# Access Compliance Report

## Public Rights-of-Way

Intersection ID: 8700	Main Street: L_D PARKER DR	Cross Street: HOLLAND AV	Location: NE
ADA ID: F15920B9FF13	Ramp Type: PerpDiag	Initial Pass/Fail: Fail	Overall Compliance: No
Severity Score: 35			
Codes/Mitigation Info/Possible Solution		Field Measurements/Component Compliance

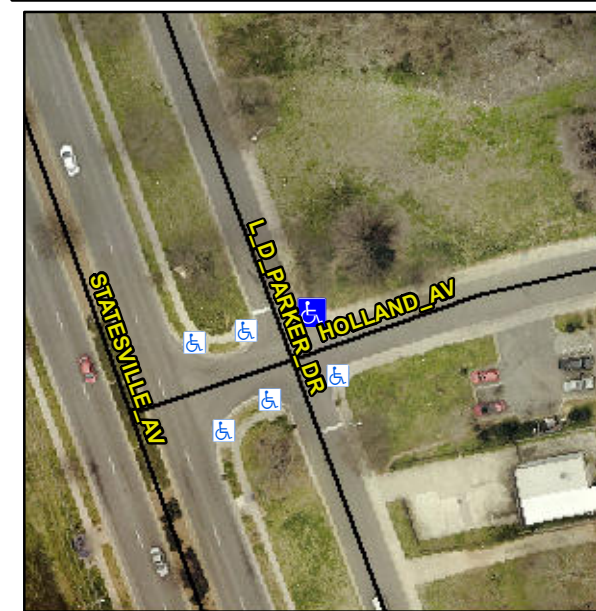
**Not Found, R304.5.1**

Compliance	Description	Data	Compliance	Description	Data
N/A	Ramp Length (in)	59.5	Yes	Ramp Slope (%)	5.5
No	Ramp Width (in)	28.5	Yes	Ramp XSlope (%)	0.7
N/A	Flare Type LT	N/A	N/A	Flare Type RT	N/A
N/A	Flare Slope LT (%)	N/A	N/A	Flare Slope RT (%)	N/A
N/A	Flare Traversable LT?	N/A	N/A	Flare Traversable RT?	N/A
N/A	Landing Length (in)	N/A	N/A	DWS Provided?	N/A
N/A	Landing Width (in)	N/A	N/A	DWS Contrast?	N/A
N/A	Landing Slope (%)	N/A	N/A	DWS Length (in)	N/A
N/A	Landing X Slope (%)	N/A	N/A	DWS Full Width?	N/A
N/A	Landing Curb? (Y/N)	N/A	N/A	DWS Offset (in)	N/A
N/A	Shared Landing?	N/A			
N/A	Gutter Ponding?	N/A	N/A	Gutter Slope (%)	N/A
N/A	Gutter Lip Ht (in)	N/A	N/A	Gutter X Slope (%)	N/A
N/A	Painted X Walk1?	No	N/A	Painted X Walk2?	No
	X Walk 1 Direction	To W		X Walk 2 Direction	To S
N/A	X Walk 1 Width (in)	N/A	N/A	X Walk 2 Width (in)	N/A
	X Walk 1 Slope (%)	1.9		X Walk 2 Slope (%)	1.5
	X Walk 1 X Slope (%)	0.4		X Walk 2 X Slope (%)	1.5

**Remove & Replace Curb Ramp With Two New Directional Ramps or Equivalent.**
